**NORTHSIDE/ JOINT VENTURE SUBDIVISION AND**  
**AMERICAN RED CROSS SUBDIVISION, LOT 2,**  
**RESUBDIVISION OF LOT 1**

APPLICATION NUMBER 14 DATE January 16, 2014

REQUEST Subdivision

# DETAIL SITE PLAN

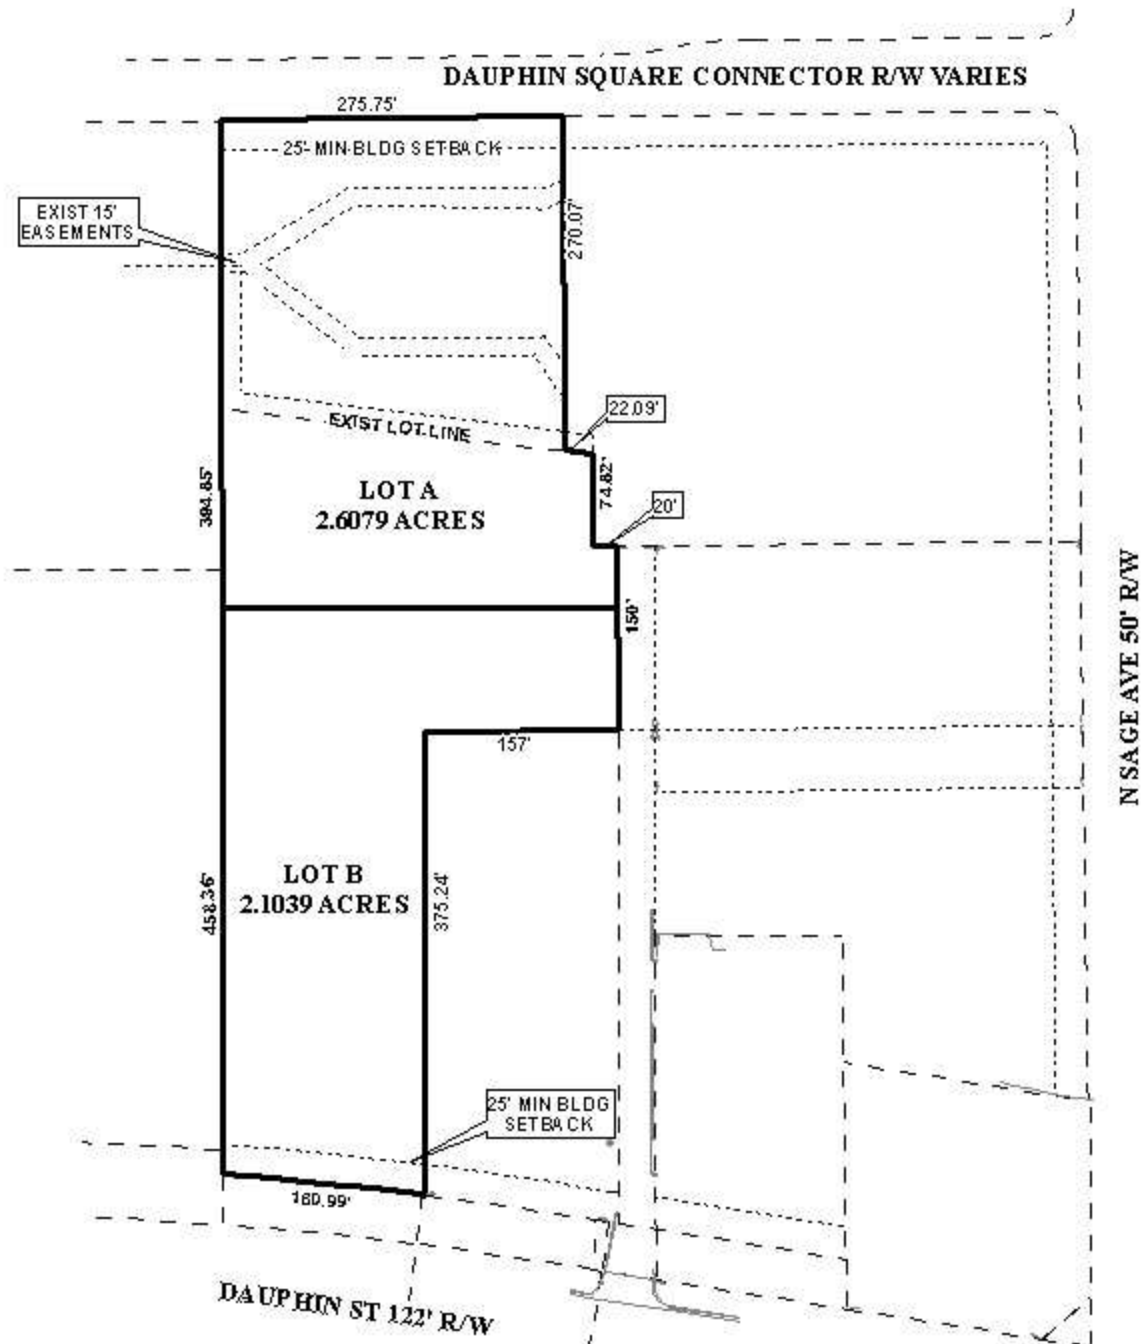
The site fronts onto Dauphin Street, a major street, with a right-of-way illustrated as 122-feet and Dauphin Square Connector, a minor street, with a right-of-way of 50-feet. Both streets meet the minimum right-of-way widths as required by the Subdivision Regulations and the Major Street Component of the Comprehensive Plan. If approved, both the 122' and 50' right-of-way widths and labels should be retained on the Final Plat.

Access management is a concern thus; a note should be placed on the Final Plat stating the site should be limited to one curb-cut onto the Dauphin Street, and one curb-cut to Dauphin Square Connector, with the size, design and location to be approved by Traffic Engineering, and conform to AASHTO standards.

The 25' minimum building setback line is indicated on the preliminary plat; and should be retained on the Final Plat, if approved.

The plat illustrates the lots of adequate size and adequate public right-of-way access to meet the minimum requirements of the Subdivision Regulations. The lot sizes, in square feet, are shown on the preliminary plat and should be retained on the Final Plat, if approved.

The proposed Lot A currently has drainage easements that run throughout property. There is a note located on the preliminary plat that states, "*this drawing does not reflect any title, easement or right-of-way research other than what is readily visible on the surface or provided by the client*". A note should be placed on the Final Plat stating no structures shall be constructed or placed in any easements.
